Loreto Kirribilli – Western Precinct

PRELIMINARY BCA ASSESSMENT

REPORT 2016/1744 R1.4

Loreto Kirribilli – Connectors to Northern, Eastern and Southern Precinct

Figure 1 - Performance based separation at ground floor. Level 1 and 2 to also be addressed

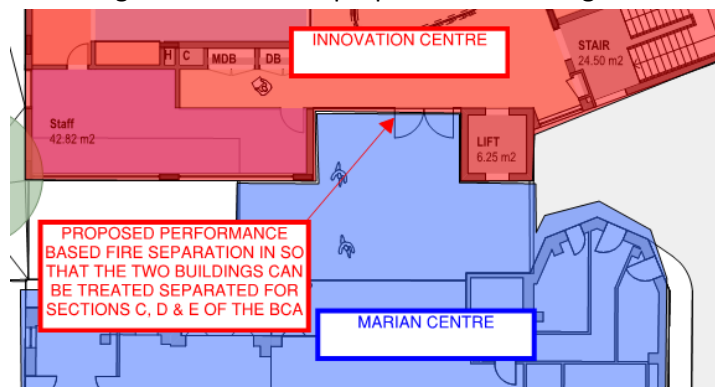
Section C – Fire Resistance:

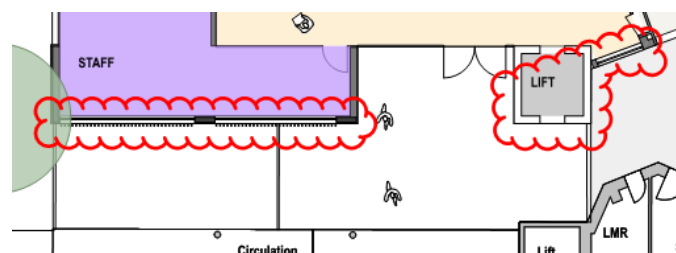
- The external walls of the new innovation centre and the existing Marian Centre are less than 6m apart in some areas. As a result, any openings that are within 6m of the external wall of the opposite building must be protected in accordance with C3.4 (i.e. fixed shut windows with drenchers, self closing fire doors, or self closing doors with drenchers). A fire engineered solution can be investigated where compliant protection of openings is not provided.
- Furthermore, the glazed openings on the ground floor clouded below, occupy more than 1/3 of the external wall they are located in. A fire engineered solution is required to be investigated.

Figure 2 - Performance based separation between Innovation Centre and Centenary Hall

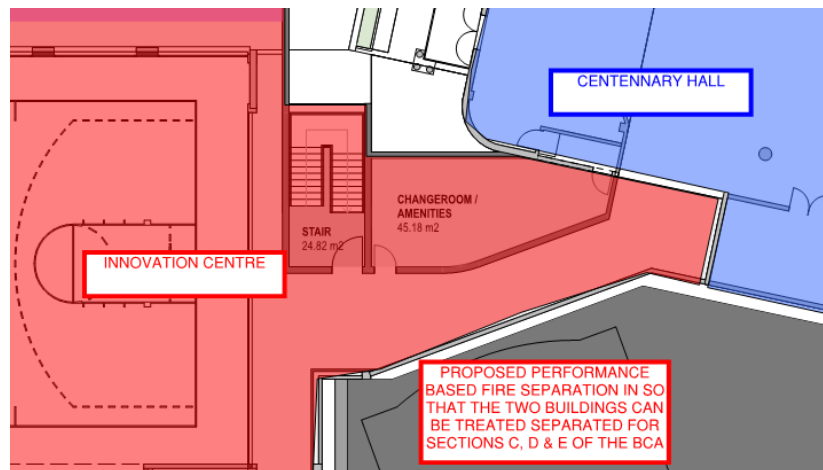
- The BCA reports completed for the centenary hall identifies that the building was built to type C fire resisting construction whilst the Junior School was built to Type B fire resisting construction. As a result, the gymnasium/innovation centre are proposed to be fire separated from the adjoining Centenary Hall and Junior School.
- The fire walls separating the compartments will not fully comply with Clause C2.7. A fire engineered solution is proposed to be investigated for a performance based fire wall for the separation of each of the buildings. It is proposed that the fire wall design separates each of the 3 buildings (Innovation Centre/Gymnasium; Centenary Hall; and Junior School) so that they may be **treated as separated buildings for the purposes of Section C, D and E of the BCA.**

Figure 3 - Performance based separation between Innovation Centre and Junior School

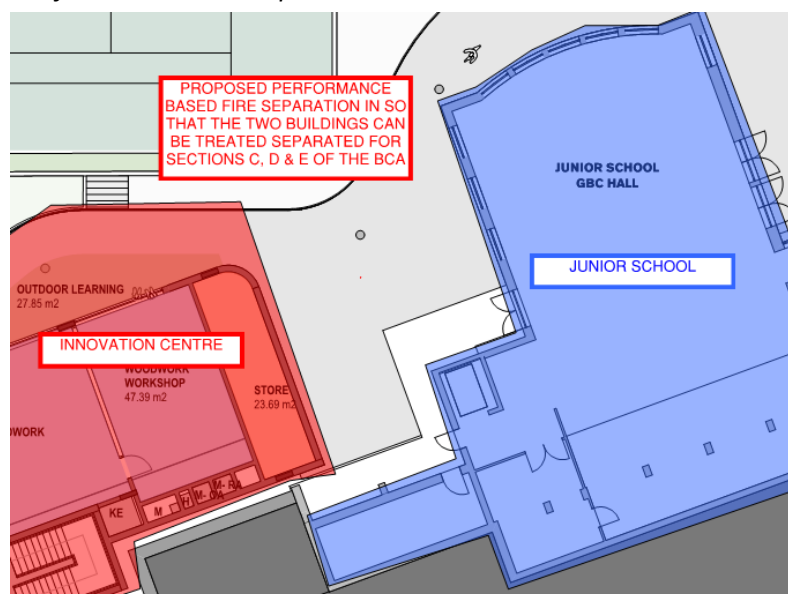
- External walls of the Centenary Hall and Junior School which are within 6m of an external wall of the new innovation centre/gymnasium are required to achieve a 2hr FRL. As a result, any openings that are within 6m of the external wall of the opposite building must be protected in accordance with C3.4 (i.e. fixed shut windows with drenchers, self closing fire doors, or self closing doors with drenchers). A fire engineered solution can be investigated where compliant protection of openings is not provided.
- Openings within 3m of the side boundary are required to be protected in accordance with Clause C3.4 of the BCA.

Figure 4 – Protection of openings from discharge of stairway

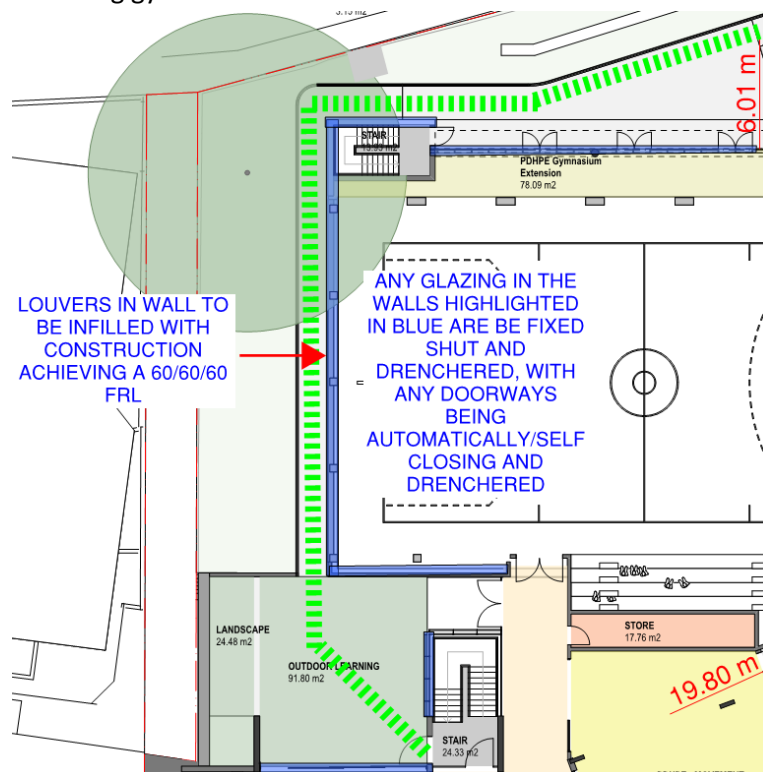
- In accordance with Clause D1.7, where the discharge from either of the two exit stairways necessitates passing within 6m of an opening in an external wall, those openings must be protected in accordance with C3.3 i.e. windows fixed shut with drenchers and self closing fire rated doorways. The protection is only required where the path of travel is exposed to openings measured at right angles. A fire engineered solution can be investigated to reduce the extent of protection if possible. Note, the existing low level louvers in the western elevation of the existing gymnasium should be filled in to achieve an FRL of 120/120/120.

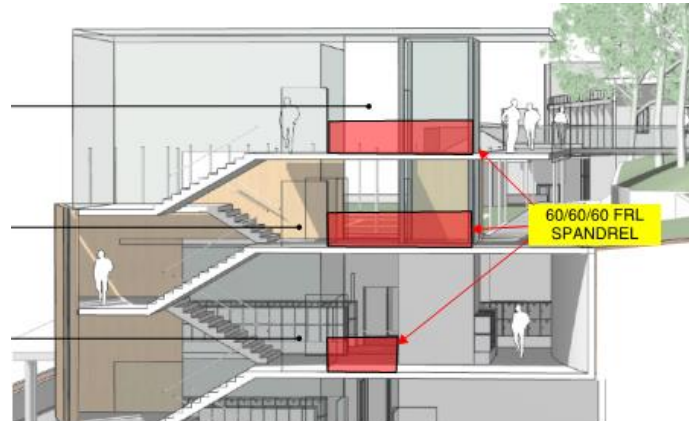
- The fire walls separating the compartments will not fully comply with Clause C2.7 due to the glazing and glass doors opening into the foyer of the Centenary Hall. A fire engineered solution is proposed to be investigated for a performance based fire wall for the separation of the buildings. It is proposed that the fire wall design separates the two buildings so that they may be **treated as separated buildings for the purposes of Section C, D and E of the BCA.**
- The new external walls are required to be provided with spandrels complying with Clause C2.6 to stop vertical fire spread. Spandrels are not required to external walls only serving the lobby.

Alternaveitly a fire engineered solution can be investigated to eliminate spandrels given the low fuel load in this space.

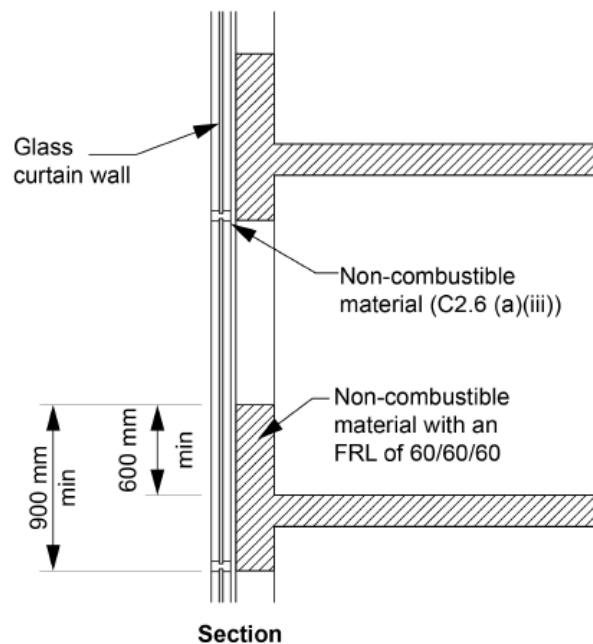
- The construction of the ramp directly above the discharge of the exit stairway from the carpark has significantly enclosed the space picture below. This results in the class 7a carpark having a direct connection to the class 9b area above. As a result, the top of the stairway is required to be provided with a -/120/30 fire door to ensure that separation of the classifications has been maintained.

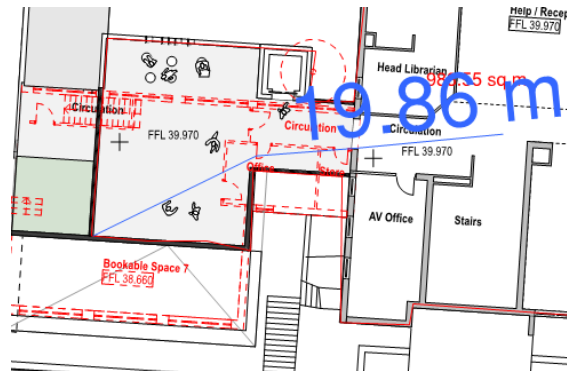
- Access to 2 exits is provided from each area in accordance with Clause D1.2.
- The existing stairway within the J Block connects 4 storeys and is not fire isolated and therefore does not comply with BCA Clause D1.3. However, we note that this is an existing non compliance which is not being further exacerbated by the proposed works. As a result, a CC can still be issued for the works as there has been no reduction in fire safety in accordance with the EP&A Regulation.
- The travel distances throughout the new areas comply with Clause D1.4 and D1.5 of the BCA. The travel distances are as follows:
 - Level I – 20m to a point of choice is available from the new area to the existing stairway within the J block.

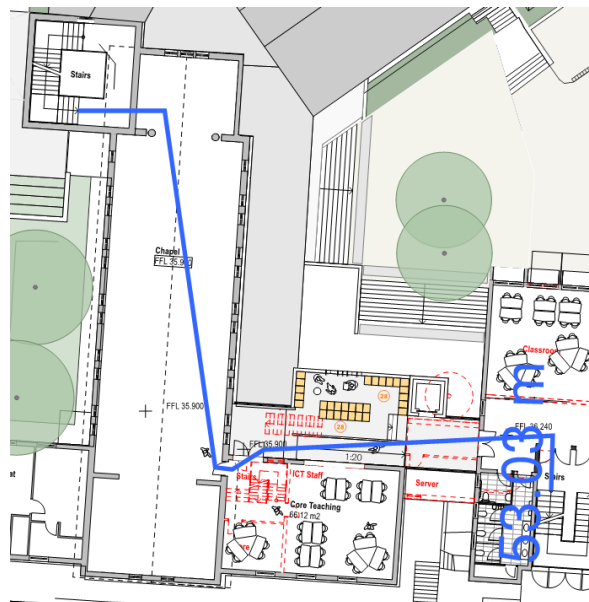
- Level H – Travel distances within the chapel and new link area comply. A 20m point of choice can be obtained and the distance between alternative exits still complies via the stair to the rear of the Chapel. Confirmer to be provided that there is a door leading into the Chapel stairway.
